RE: Nob Hill Apartments

Permanent C.O. - Approved

Hydrology File: K17D073

DRAINAGE AND TRANSPORTATION INFORMATION SHEET (REV 11/2018)

CG-101

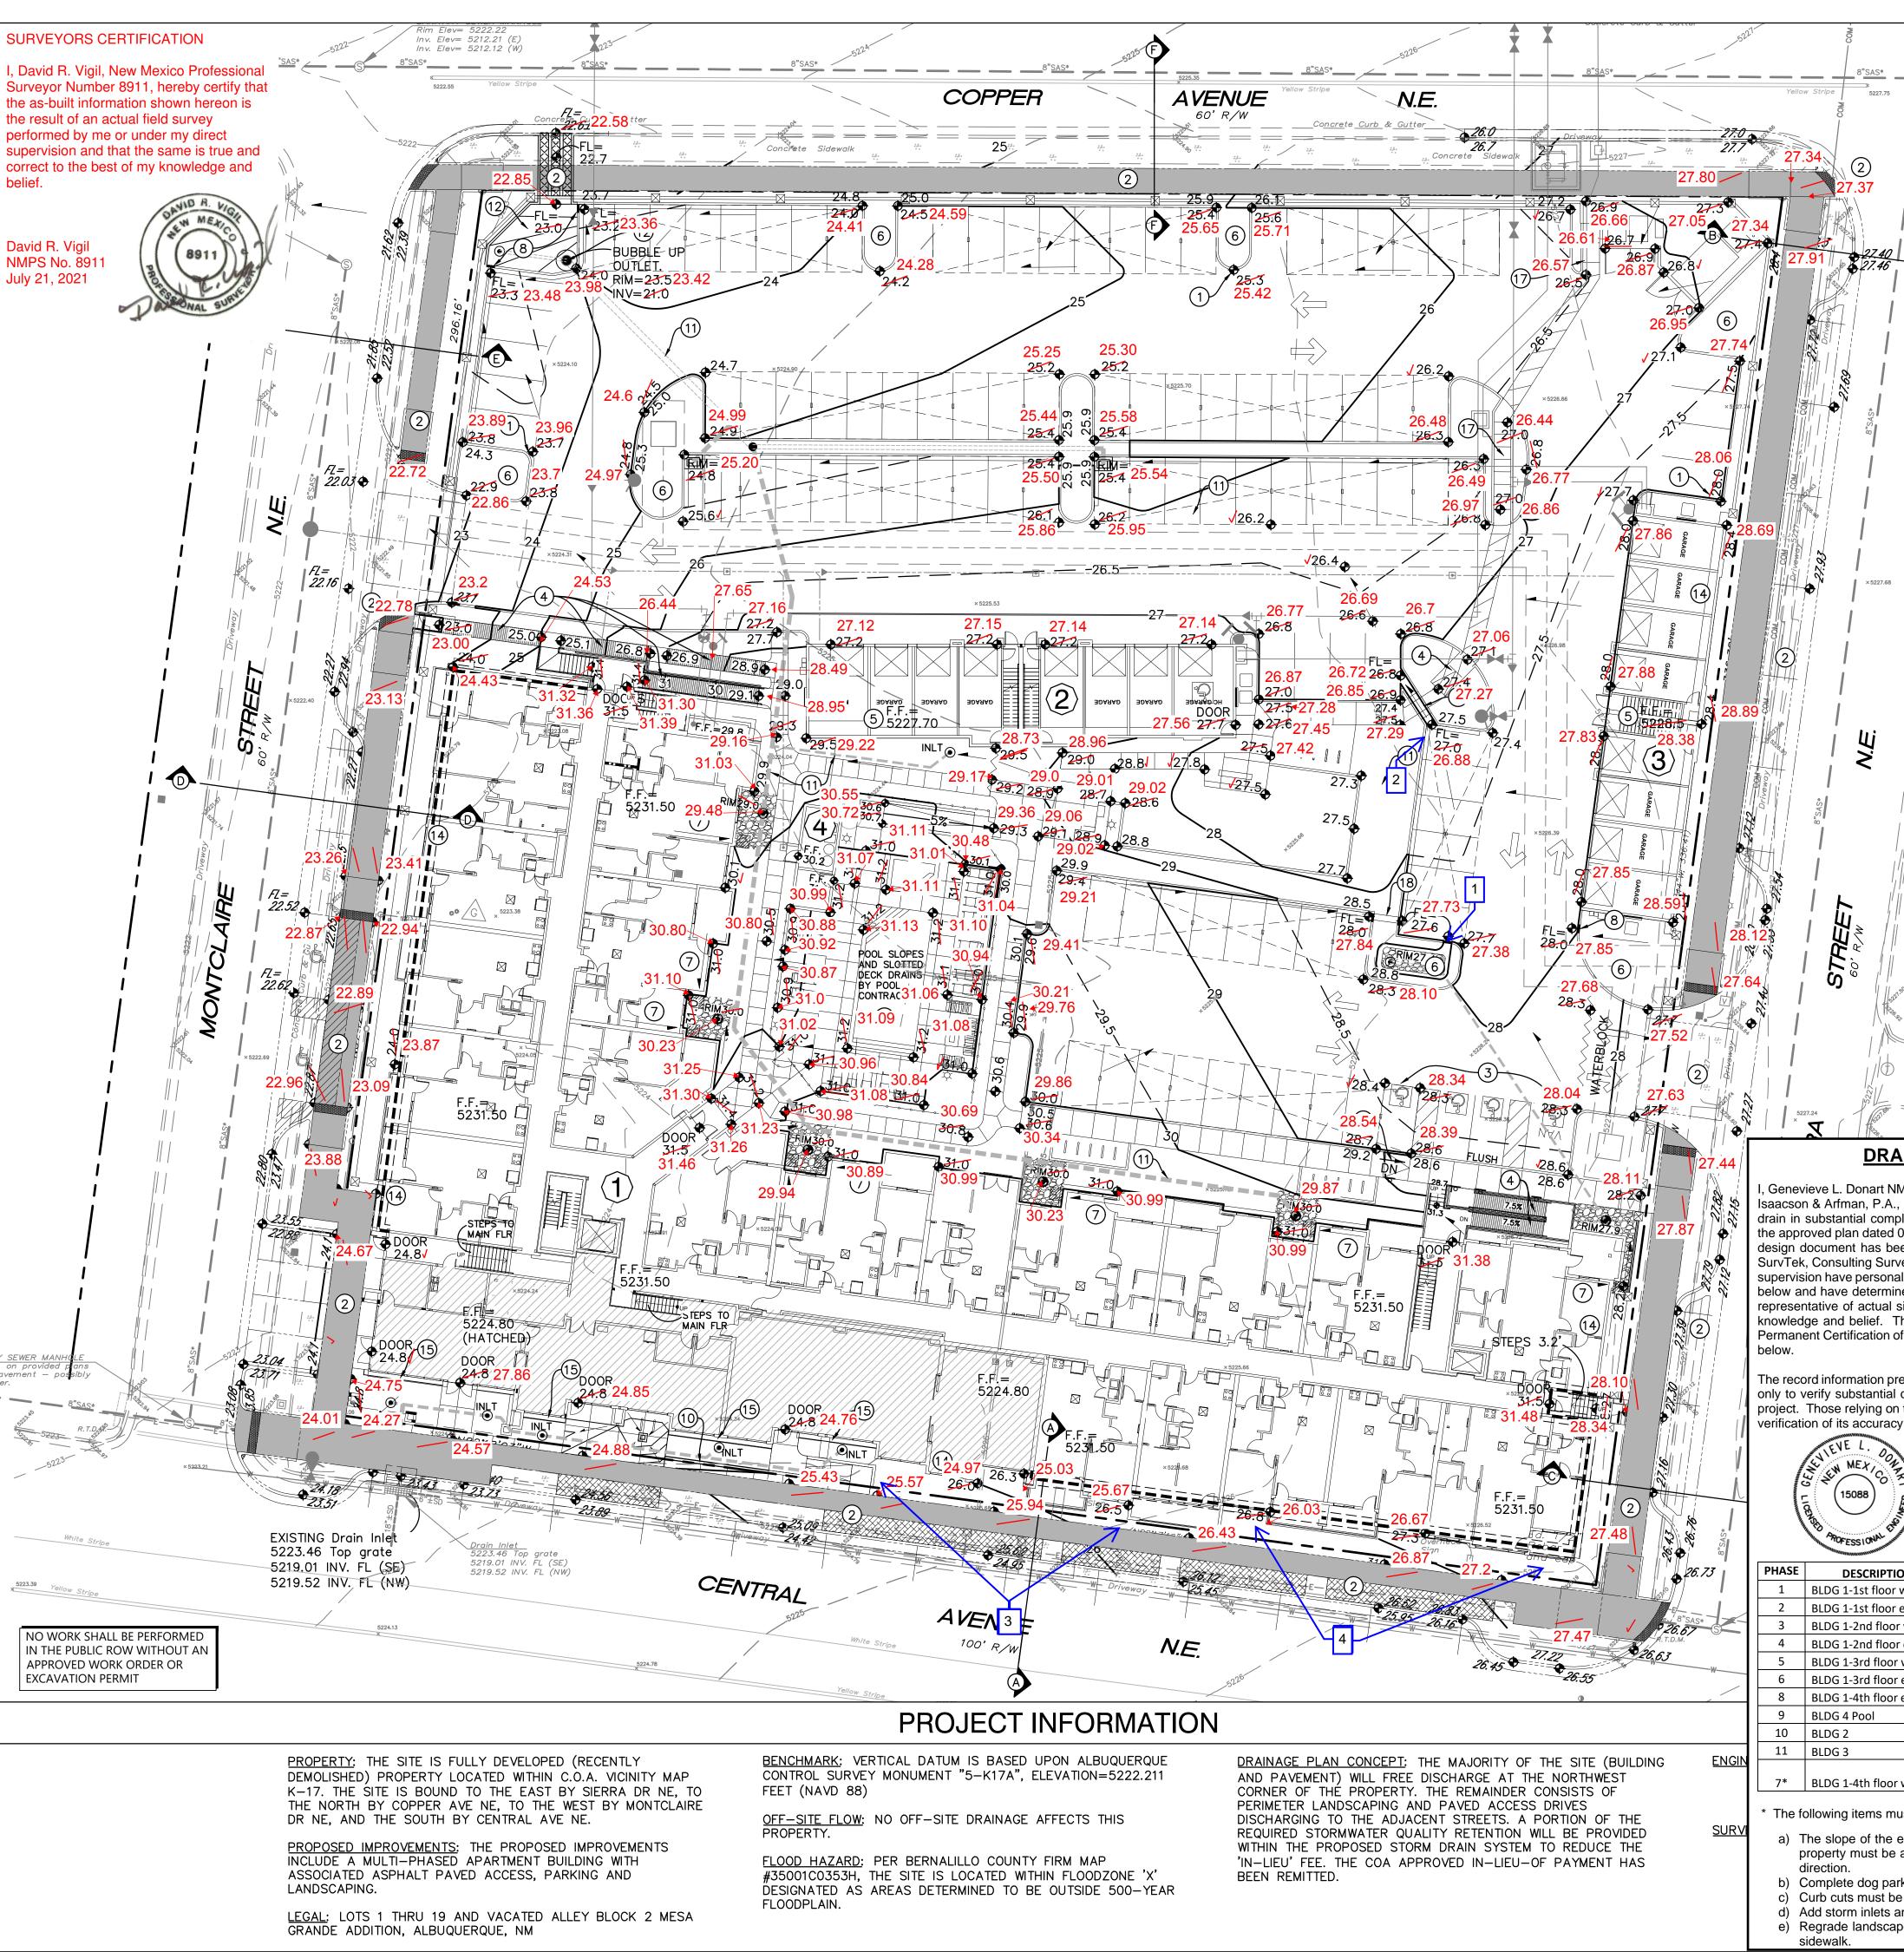
Albuquerque There are a few minor clean up items that the contractor need to attend to. Please make sure all

dome inlet caps are attached (a few were sitting on the side). Remove filter fabric covering any inlets. Make sure landscaping stone is arraigned as per plan (several locations it was still piled

inlets. Make sure landscaping stone is arraigned as per plan (several locations it was still piled

- a) The slope of the easternmost ADA parking space in the SE corner of the property must be adjusted to have no more than 2.0% cross-slope in any property must be adjusted to have no more than 2.0% cross-slope in any
- b) Complete dog park in Phase 9 and provide as-built elevations c) Curb cuts must be added at locations_1 & 2
- d) Add storm inlets and drain at location 🛂 📙 e) Regrade landscape area at location 4 so that it drains south across the

The following items must be completed prior to certification of Phase 7:
